Access Compliance Report

Public Rights-of-Way

(Curb Ramps)

Intersection ID: 10029652	Main Street: KINGS_CROWN_WY	Cross Street: N/A	Location: SE
ADA ID: 68F1D4640DAE	Ramp Type: BlendTrans1	Initial Pass/Fail: Fail	Overall Compliance: No
		Severity Score: 12.5

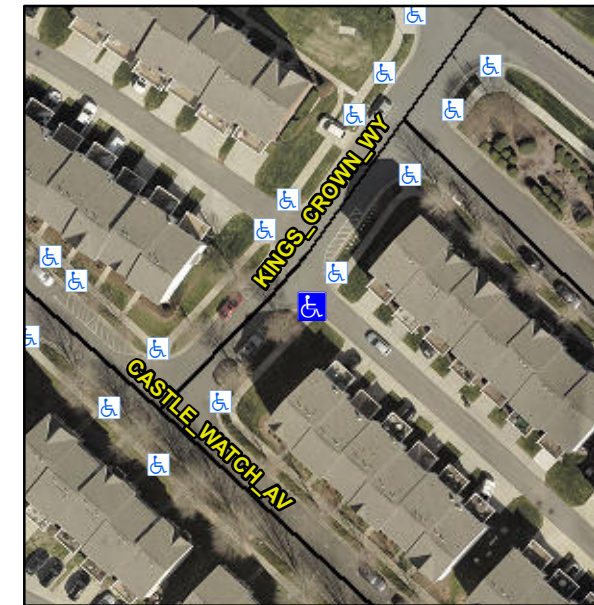
R304.5.3

Compliance	Description	Data	Compliance	Description	Data
N/A	Ramp Length (in)	50.0	Yes	BlendTrans Slope (%)	1.8
Yes	Ramp Width (in)	48.0	No	BlendTrans XSlope (%)	5.2
N/A	Flare Type LT	N/A	N/A	Flare Type RT	N/A
N/A	Flare Slope LT (%)	N/A	N/A	Flare Slope RT (%)	N/A
N/A	Flare Traversable LT?	N/A	N/A	Flare Traversable RT?	N/A
N/A	Landing Length (in)	N/A	N/A	DWS Provided?	N/A
N/A	Landing Width (in)	N/A	N/A	DWS Contrast?	N/A
N/A	Landing Slope (%)	N/A	N/A	DWS Length (in)	N/A
N/A	Landing X Slope (%)	N/A	N/A	DWS Full Width?	N/A
N/A	Landing Curb? (Y/N)	N/A	N/A	DWS Offset (in)	N/A
N/A	Shared Landing?	N/A			
N/A	Gutter Ponding?	N/A	N/A	Gutter Slope (%)	N/A
N/A	Gutter Lip Ht (in)	N/A	N/A	Gutter X Slope (%)	N/A
N/A	Painted X Walk1?	No	N/A	Painted X Walk2?	N/A
	X Walk 1 Direction	To NE		X Walk 2 Direction	N/A
	X Walk 1 Width (in)	N/A		X Walk 2 Width (in)	N/A
	X Walk 1 Slope (%)	2.8		X Walk 2 Slope (%)	N/A
	X Walk 1 X Slope (%)	0.8		X Walk 2 X Slope (%)	N/A

Remove & Replace Curb Ramp With Two New Directional Ramps or Equivalent.
